RE: City of Decatur WWTP Inspection
AFIN: 04-00052 **Permit No.: AR0022292**

<p>ENVIRONMENTAL QUALITY</p>	OFFICE OF WATER QUALITY INSPECTION REPORT				
	AFIN: 04-00052	PERMIT #: AR0022292	DATE: 11/16/2021		
	COUNTY: 04 Benton	PDS #: 123277	MEDIA: WN		
	GPS LAT: 36.34417 LONG: -94.47271 LOCATION: General Area				
FACILITY INFORMATION		INSPECTION INFORMATION			
NAME: City of Decatur WWTP LOCATION: 985 Austin Avenue CITY: Decatur		FACILITY TYPE: 1 - Municipal INSPECTOR ID#: 104111 S - State FACILITY EVALUATION RATING: 1 - Unsatisfactory INSPECTION TYPE: Compliance Evaluation			
RESPONSIBLE OFFICIAL		DATE(S): 11/16/2021 ENTRY TIME: 10:34 EXIT TIME: 15:00 PERMIT EFFECTIVE DATE: 11/30/2020 PERMIT EXPIRATION DATE: 11/30/2025			
NAME: / TITLE Robert Tharp / Mayor COMPANY: City of Decatur MAILING ADDRESS: PO Box 247 CITY, STATE, ZIP: Decatur AR 72722 PHONE & EXT: / FAX: 479-752-3912 / EMAIL: bobtharp@decaturarkansas.us & james.boston@decaturarkansas.us		FAYETTEVILLE SHALE RELATED: N FAYETTEVILLE SHALE VIOLATIONS: N

Decatur Equalization Pond

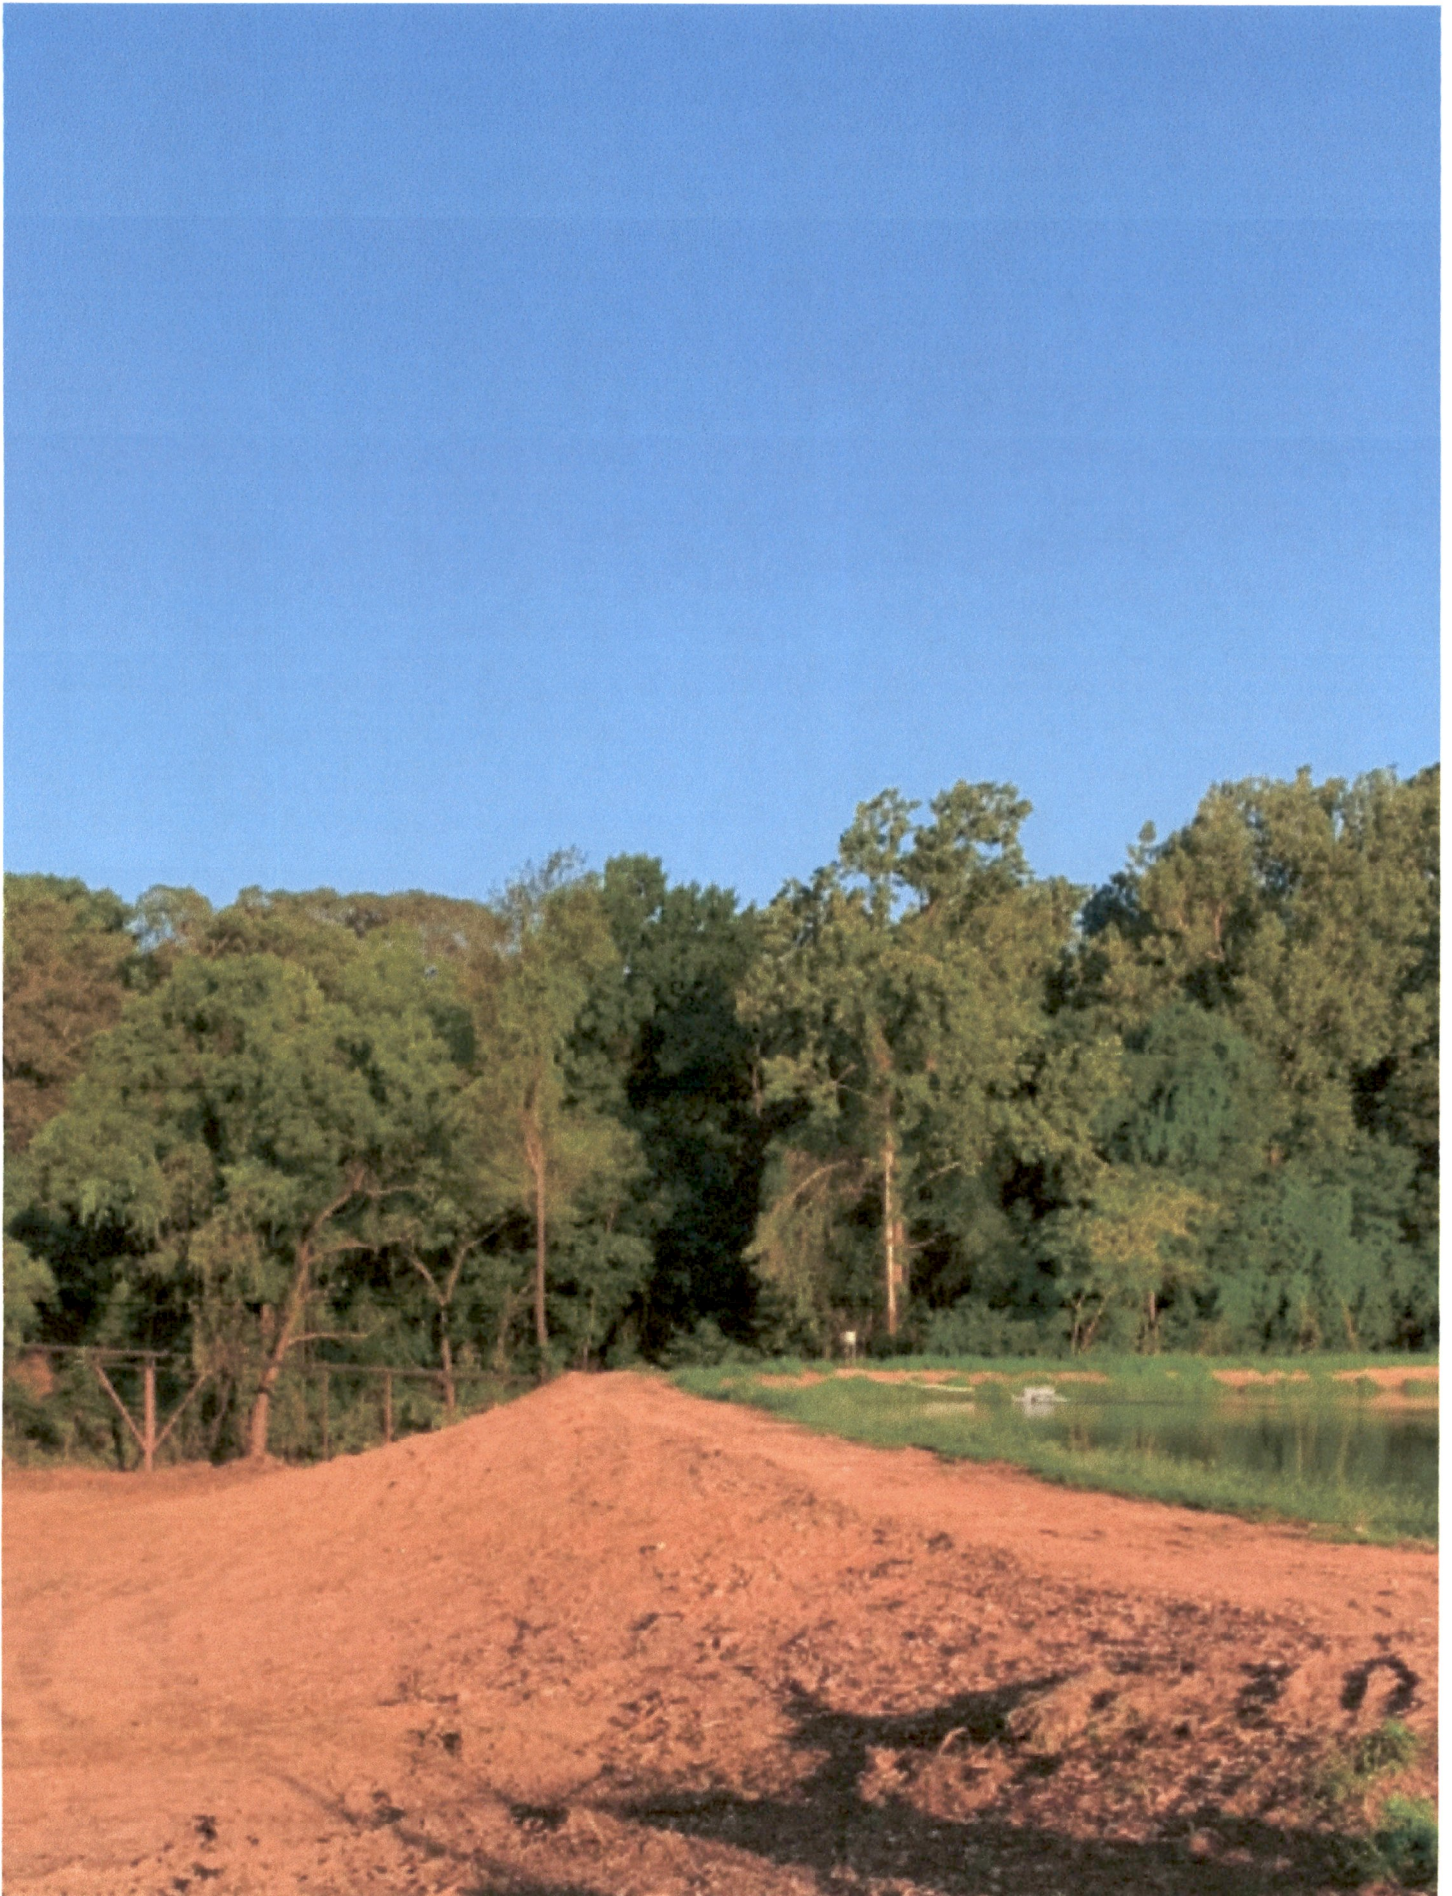
3. Item 3 dealt with the equalization pond that we still use on a daily basis. We did have a lot of vegetation that was grown up in a fence on the south side of the pond. Time and attention in other places had led it to be overgrown with vegetation in the fence, and pond bank. We have now cleaned this up and done work on the pond bank or berm. I have attached a photo of what it looks like now. We have been in the process of taking bids to replace the security fence along this pond, we should have a contractor to replace the fence next week. We are aerating the pond and adding bacteria to the pond from time to time to keep it healthy. Once the expansion occurs it should only be used for rainfall events or when the plant needs to be taken off line for a maintenance event. The aerator you saw the day you were there that was off was due to it being in shallow water, that end of the pond is not as deep.
